# Value Engineering Study Report

**US 641 Connect Eddyville to Fredonia**  
Kentucky Transportation Cabinet (KYTC)

Value Engineering Study 2019-12-4  
Item #1-187.31 (#1-187.50 and #1-187.60)

*Caldwell and Lyon Counties, Kentucky*

**VE RECOMMENDATION NO. 1:  
STRENGTHEN ACCESS CONTROL**

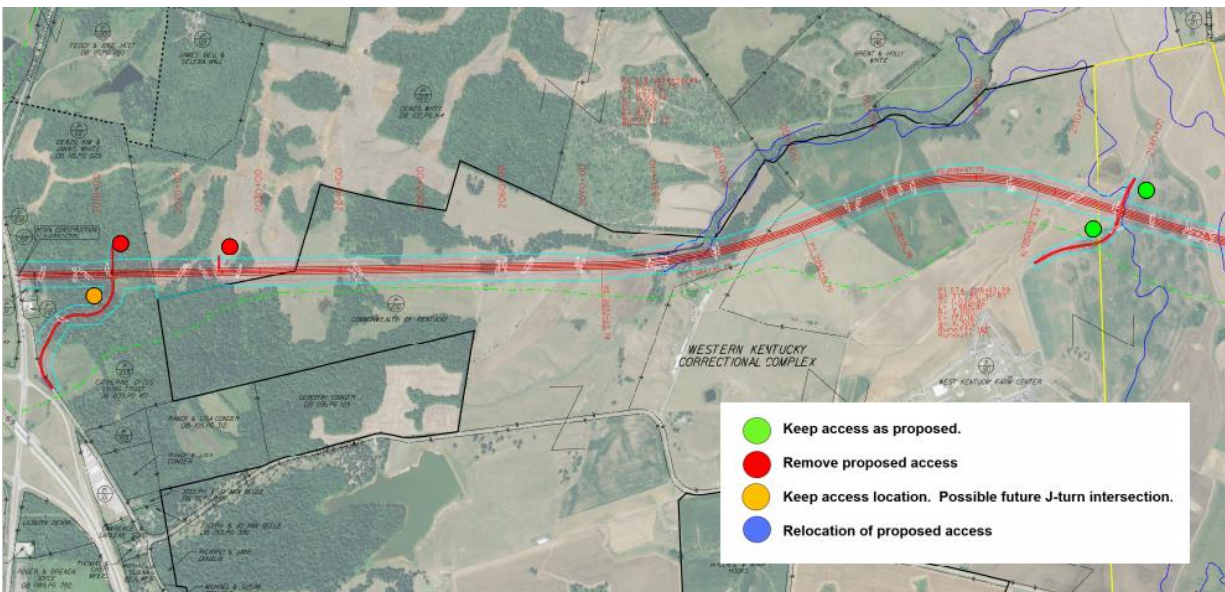
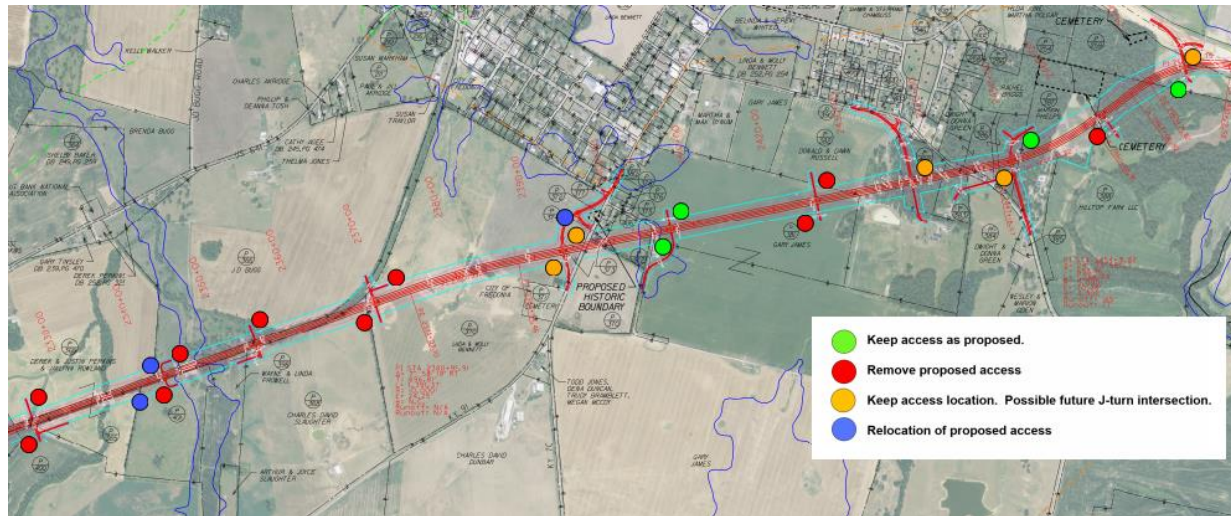
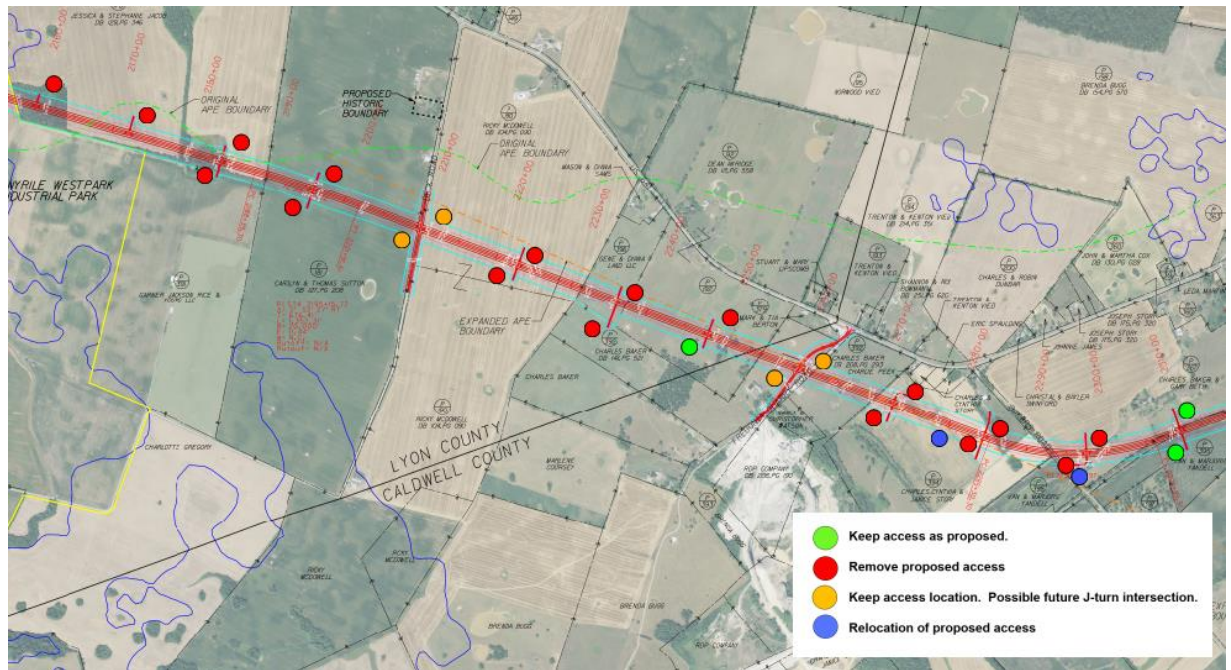
Research completed by the Kentucky Transportation Center for KYTC recommends necessary median openings and access points be separated by at least 2400' on high-speed rural arterials such as US 641. The purpose of this is to maintain the long-term mobility and safety of the corridors that connect cities and other destinations over long distances. Local access is meant to be achieved primarily from lower functional classification roadways.

This recommendation is primarily to preserve the mobility and safety of the corridor. However, there are cost savings nearing \$1 million from the removal of so many entrances.

**VE RECOMMENDATION NO. 2:  
DESIGN FOR TWO CONSTRUCTION SECTIONS**

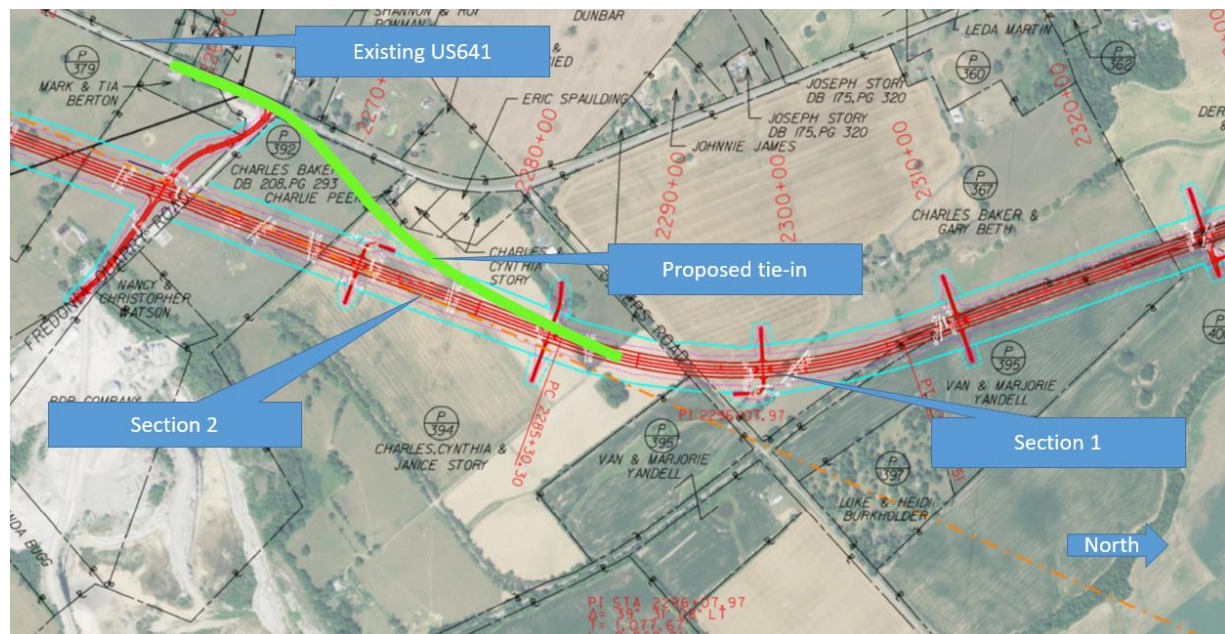
This proposal is to divide the project into two construction sections, the first of which can be operational upon completion. Because this is such a large project requiring over \$50 million in funding to complete (the initial 2-lane phase), it is unlikely to receive all the funding it needs in the next several highway plan cycles. Splitting into smaller sections with logical termini will increase the likelihood of advancing the project to phases beyond design and getting construction underway.

The project is broken into two projects in the current highway plan. However, the division is identified at Beck Road, a location on the corridor that does not facilitate a quality temporary tie-in to the existing route.

A logical location to make the division is just south of Bakers Road, where the existing and proposed alignments are at their closest proximity. There are options on precisely how to align the tie-in that will connect the two routes. One option is presented below. It is assumed that the new corridor would be built with an initial two-lane roadway, so no lane drop or lane add would be needed in the tie-in.

**Idea Nos.  
5, 19, 32**

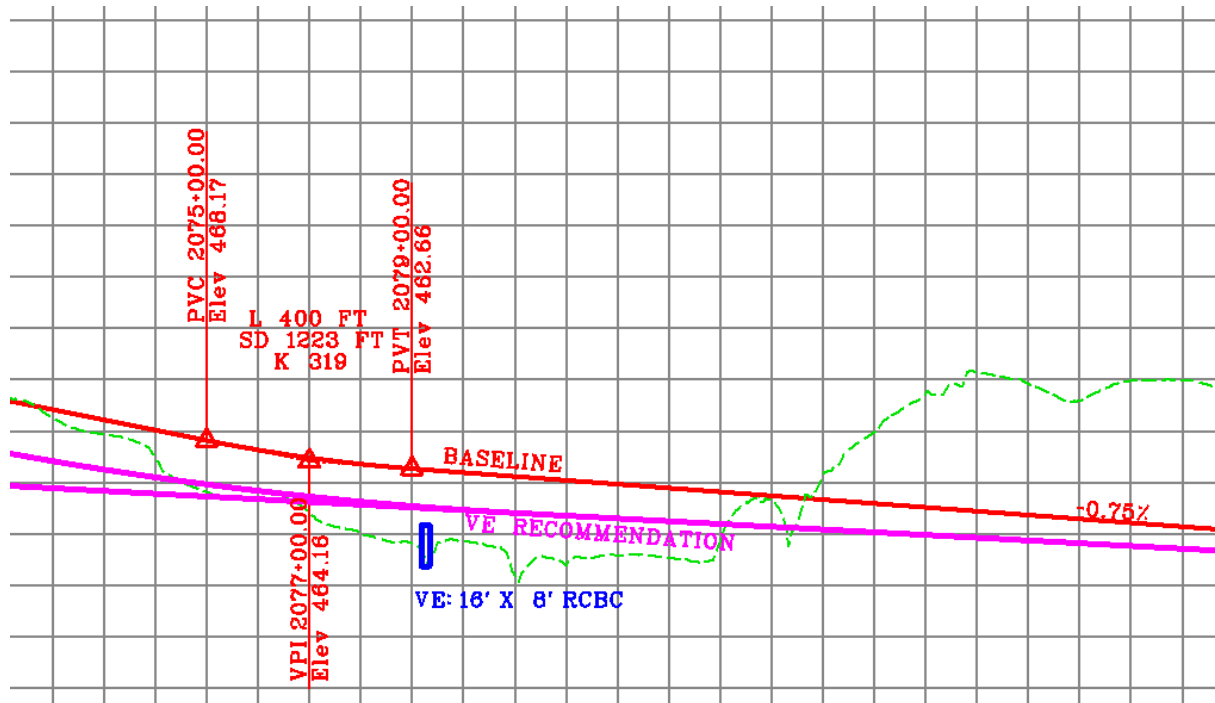
Due to the relatively high cost of embankment in place in the baseline Preliminary Line & Grade (PL&G) estimate, the VE team evaluated the baseline profile along with design assumptions to determine if optimizing the profile could better balance the earthwork needed.

**Idea Nos.  
5, 19, 32**

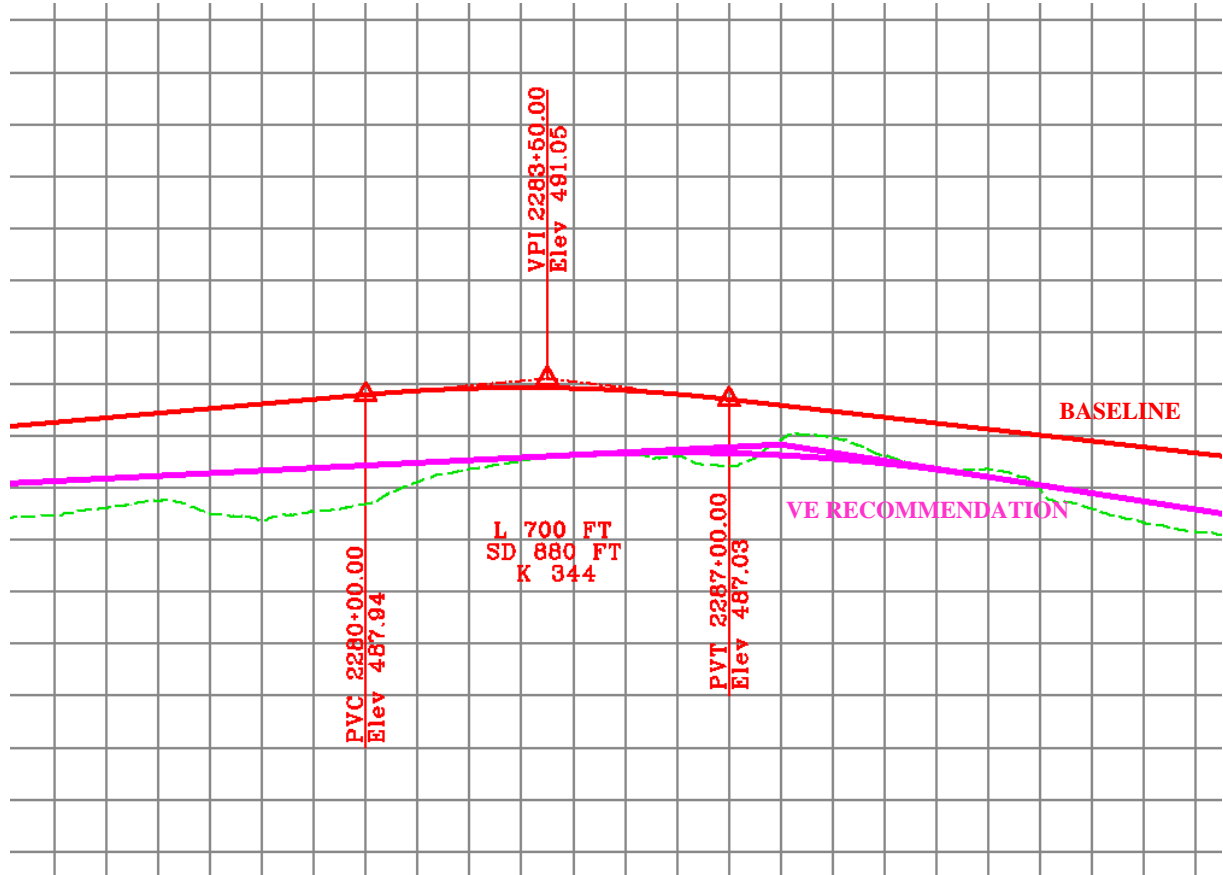
Another location that we were able to lower slightly was near the stream crossing at STA 2148+00. Although the bridge hydraulic analysis determined that the span arrangement needed to be lengthened, it also allowed for a profile grade of approximately 417.65.

**VE RECOMMENDATION NO. 3:  
OPTIMIZE PROFILE TO PROMOTE EARTHWORK  
BALANCE**

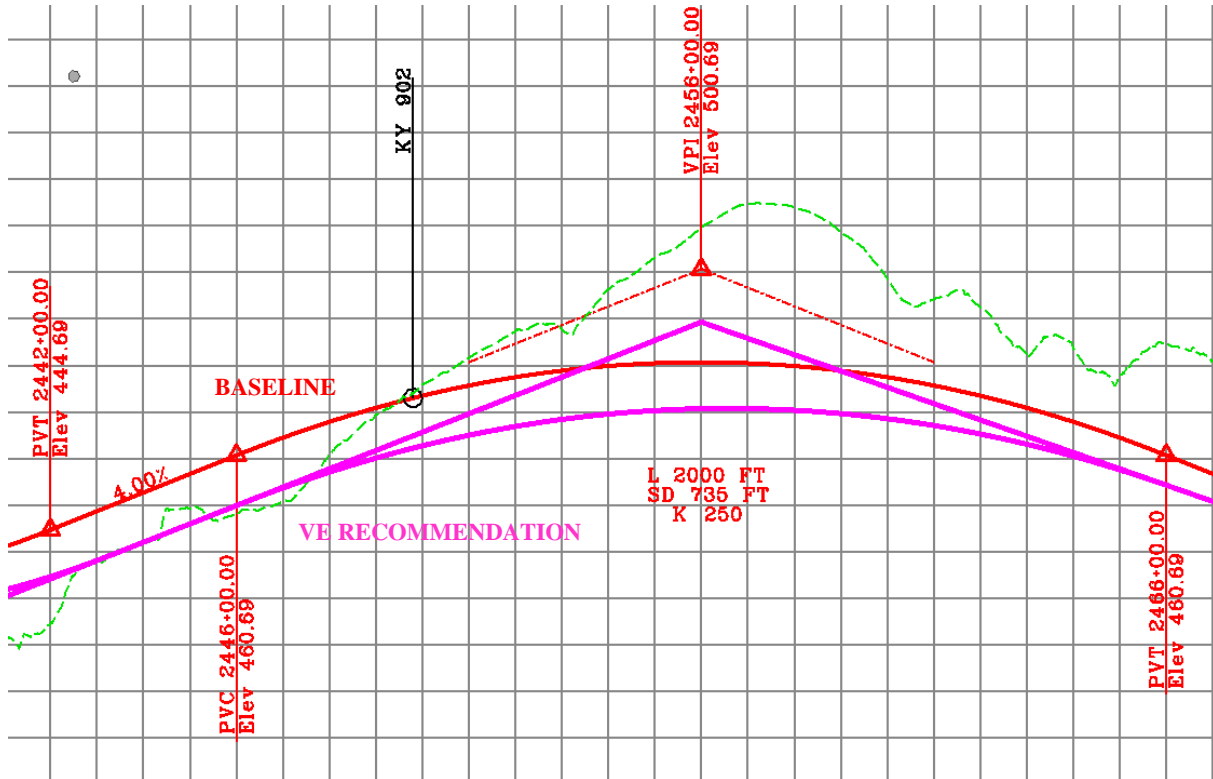
Several crest locations were adjusted lower where constraints allowed. One example location is near STA 2285+00 as illustrated below:

Near the end of the project, the profile was adjusted lower significantly while considering the road approach tie-ins with KY 902. The required maintenance of traffic will require further consideration as the project progresses through Phase 2 design as this provides an excellent source of raw material within the baseline right of way limits.

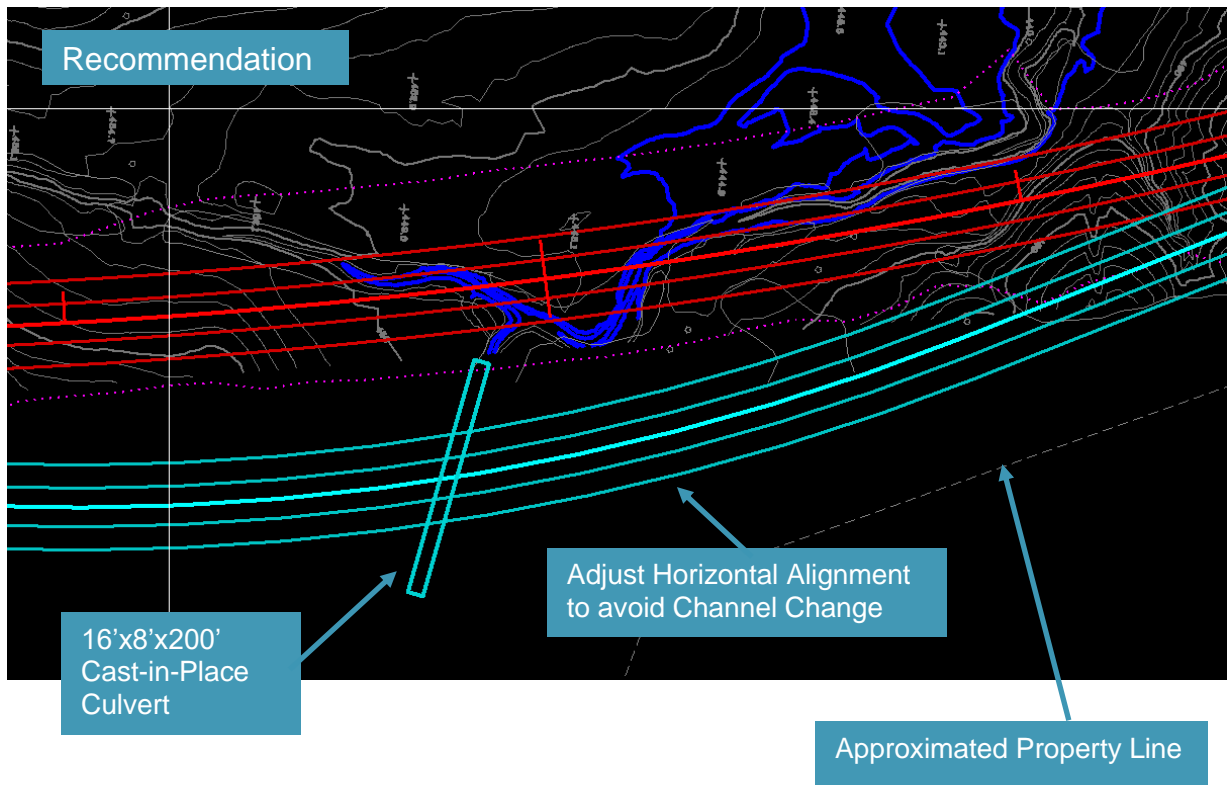
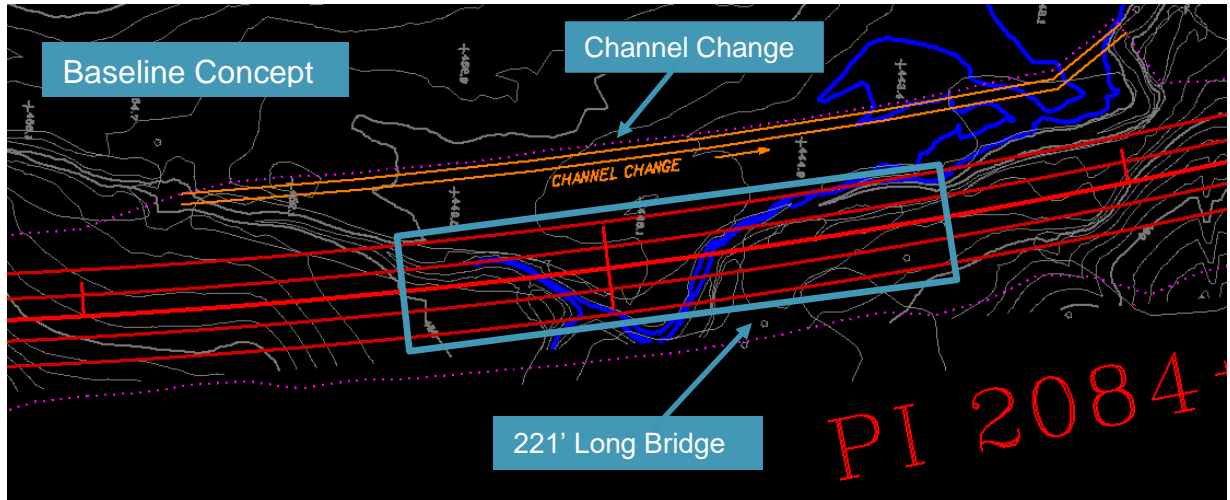
<b>Recommendation Concept</b>		
<p>The VE team reviewed preliminary layouts for the structures and recommend changes to the following three structures:</p> <p><b>Structure #1 Recommendation</b></p> <ul style="list-style-type: none"> <li>• Modify alignment to avoid channel change and use a cast-in-place box culvert</li> <li>• The alignment modification can be accomplished by taking additional right-of-way from the property west of the Western Kentucky Correctional Facility and avoiding additional impacts to the correctional facility</li> <li>• Size = 16ft x 8ft x 200ft</li> </ul> <p><b>Structure #2 Design Consideration</b></p> <ul style="list-style-type: none"> <li>• The baseline concept may increase high water elevations which may result in the need for a Conditional Letter of Map Revision (CLOMR). An item to consider as design advances would be to evaluate the drainage opening requirements and consider limiting the rise to no more than 1.0 foot. This will likely require a longer bridge.</li> </ul> <p><b>Structure #3 Recommendation</b></p> <ul style="list-style-type: none"> <li>• Use a cast-in-place box culvert</li> <li>• Size = 16ft x 8ft x 200ft</li> </ul>

**Drainage Profile / Water Surface Elevations**

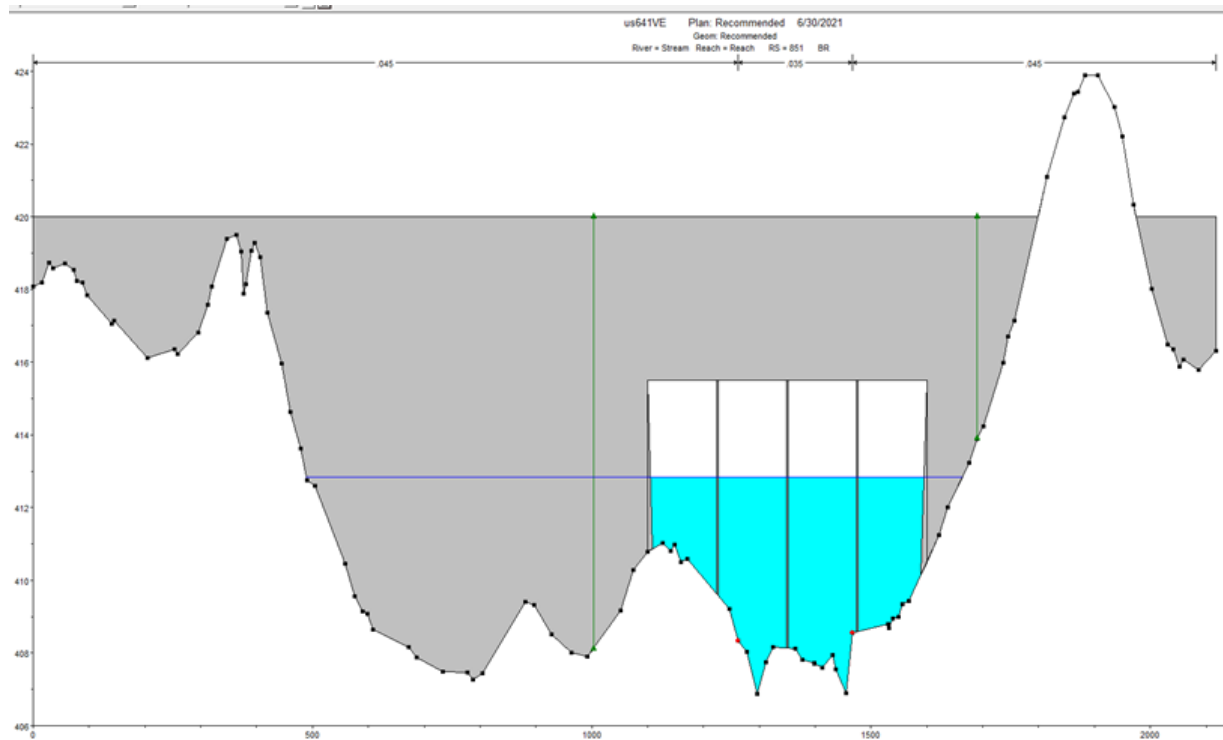
Reach	1009.009	PF 1	Existing	8410.00	412.15
Reach	1009.009	PF 1	Baseline Concept	8410.00	417.03
Reach	1009.009	PF 1	Recommended	8410.00	413.14

The Baseline Typical Section is the following:

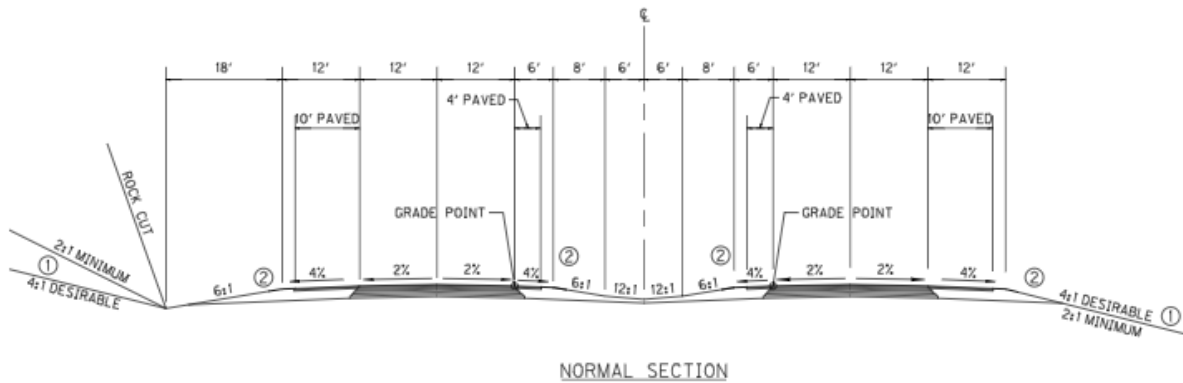
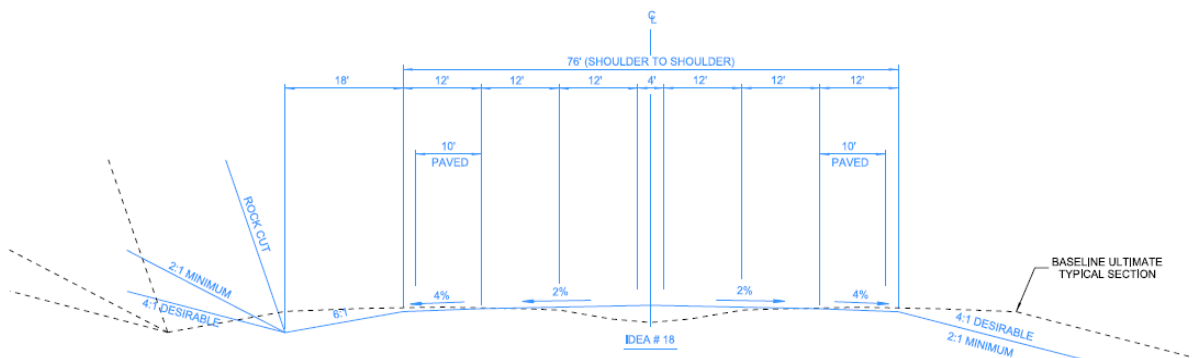
The VE team looked at three options to be able to achieve the primary functions of the project. Those three options were:

- A. Eliminate the 40' depressed median and replace it with a 4' paved median, while also maintaining the rest of the original Typical Section.
- B. Reduce outside paved shoulder width from 10' to 4'. This would leave a 2' gravel shoulder in addition to the 4' paved for a total outside shoulder width of 6' vs. the 12' in the typical section.
- C. Use the Alabama 55 cross section (four 12' lanes, 2' paved outside shoulders, 4' median).

Of these three options, the VE Team recommendation is Option A.

The VE team is recommending eliminating the 40' depressed median and replacing it with a 4' paved median. The following is the recommended typical section:
